HARD TO OPEN THE DOOR OF THE FRIDGE OR FREEZER

DESCRIPTION: The door of the freezer or refrigerator is hard to open.

SOLUTION: Exchange handle to quick release handle

Side-by-side installations using spare parts:

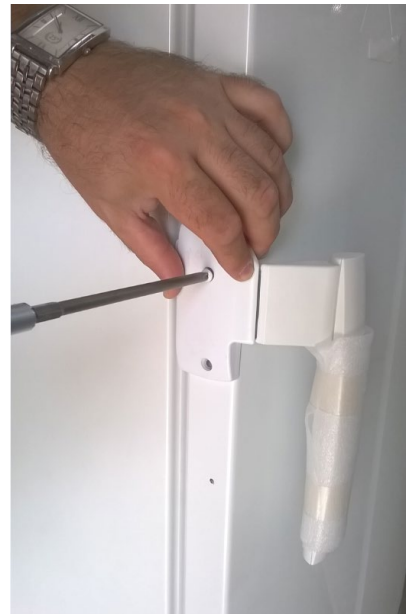
Start with handle to go on the right side appliance.

1. Mark the position of the new upper hole, - 10 mm **above** the original upper hole.

2. Drill the hole using a 2.5 mm drill.

3. Fix the first screw.

4. Drill a new hole in for the lower fastening.

Fix the second screw and cover the original hole with the plastic pin in the kit.

Then do the second handle on the appliance on the left

1. Mark the position of the new lower hole, - 10 mm **below** the original lower hole.
2. Continue as described for the first handle.
